HOLDOVER

DYSON ESTATES SUBDIVISION, FIRST ADDITION, RESUBDIVISION OF LOT 1

APPLICATION NUMBER Holdover DATE May 20, 2004

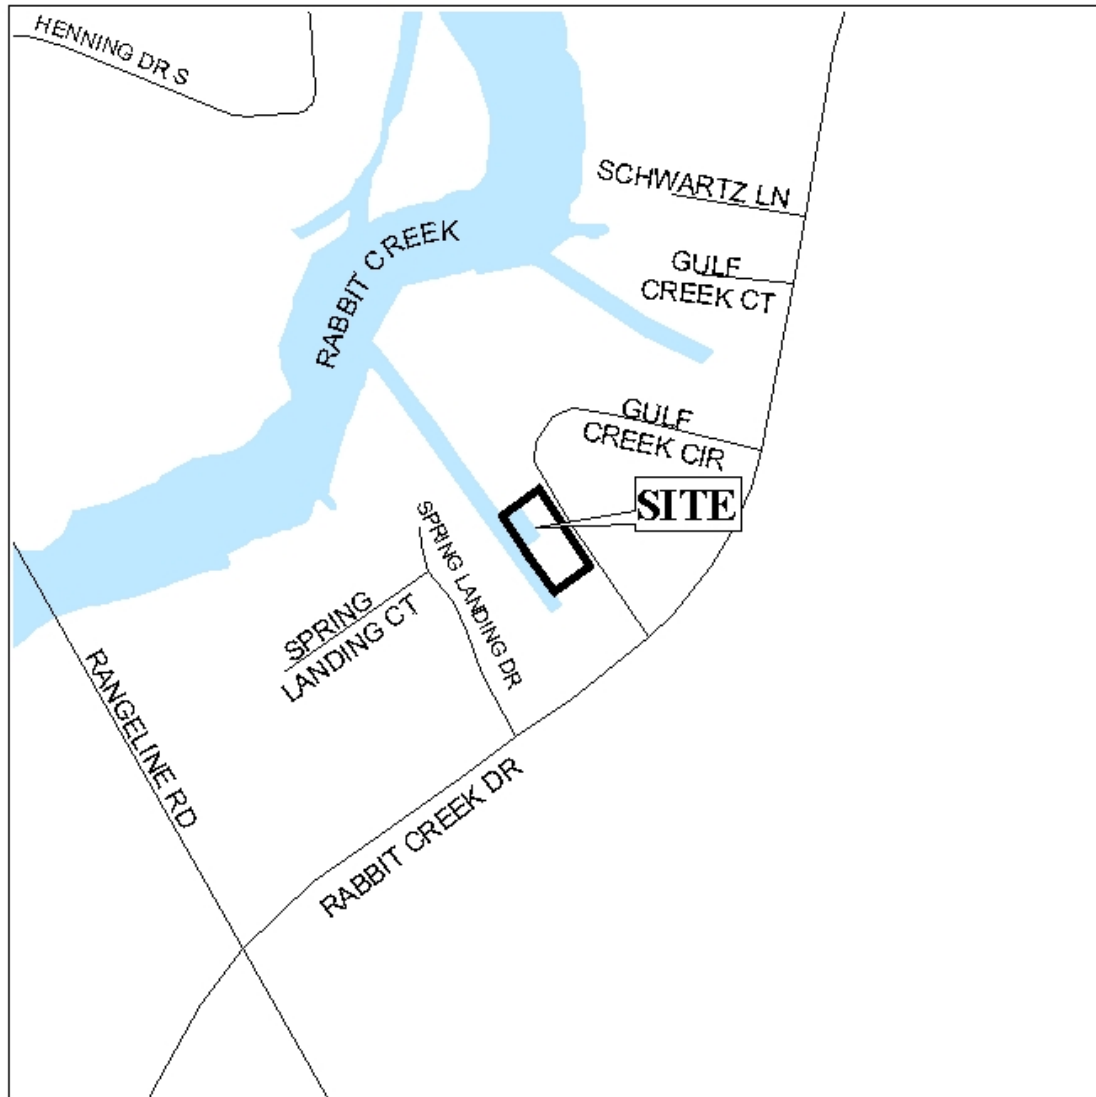
The plat illustrates the proposed 4 lot, 0.8 ± acre subdivision which is located on the South side of Gulf Creek Circle (South), 225' ± West of Rabbit Creek Drive. The subdivision is served by public water and sanitary sewer.

The proposed lots will consist of privately owned boat slips and contain approximately 1,250 square feet of area, therefore a waiver of V.D.2. would be required. Additionally, there are two common areas shown on the plat that contain 20,700 square feet, thus providing additional useable area for the site. It should be noted that the Commission has waived minimum lot size requirements in unusual situations such as billboard sites and lots for utility substations. In this situation, there is additional common area that would be useable open space. To ensure this open space remains combined with the lots, a note should be placed on the final plat stating that there will be no further resubdivision of the site. Furthermore, a note should be placed on the final plat stating that residential use is prohibited on the lots and common areas.

Two common areas are shown on the plat, thus the placement of a note on the final plat stating that maintenance of the common areas shall be the responsibility of the property owners should be required.

This site is located in the County, thus a note should be placed on the final plat stating that since the lots will not be developed residentially, a buffer in compliance with Section V.A.7. of the Subdivision Regulations must be provided where the site adjoins residential development.

With a waiver of Section V.D.2., the plat will meet the minimum requirements of the Subdivision Regulations and is recommended for Tentative Approval subject to the following conditions: 1) the approval of all applicable federal, state and local agencies; 2) the placement of a note on the final plat stating that there will be no further resubdivision of the site; 3) the placement of a note on the final plat stating that a buffer, in compliance with Section V.A.7. of the Subdivision Regulations, will be provided where the site adjoins residential development; 4) the placement of a note on the final plat stating that residential use is prohibited on the lots and common areas; and 5) the common areas be indicated on the final plat with a note stating that the maintenance thereof is the responsibility of the property owners association.

DETAIL SITE PLAN

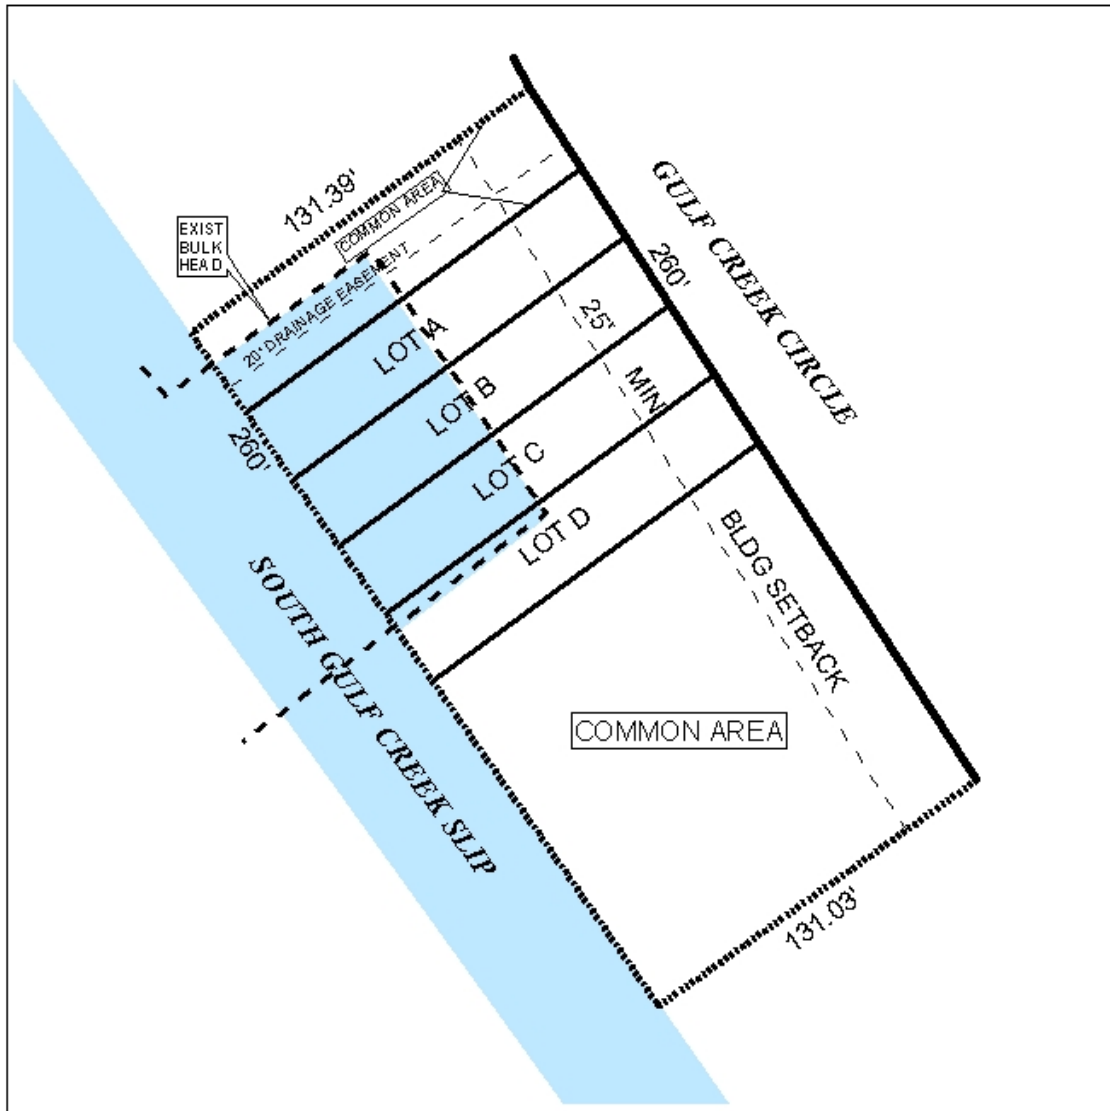
However, the applicant wants to provide a party room at each boat slip; therefore, a note should be placed on the final plat stating that construction of a domicile is prohibited on the site. This would still allow a party room on each lot.

With a waiver of Section V.D.2.(lot size), the plat will meet the minimum requirements of the Subdivision Regulations and is recommended for Tentative Approval subject to the following conditions: 1) the approval of all applicable federal, state and local agencies; 2) the placement of a note on the final plat stating that there will be no further resubdivision of the site; 3) the placement of a note on the final plat stating that a buffer, in compliance with Section V.A.7. of the Subdivision Regulations, will be provided where the site adjoins residential development; 4) the placement of a note on the final plat stating that construction of a domicile(s) is prohibited on the lots and common areas; and 5) the common areas be indicated on the final plat with a note stating that the maintenance thereof is the responsibility of the property owners association.
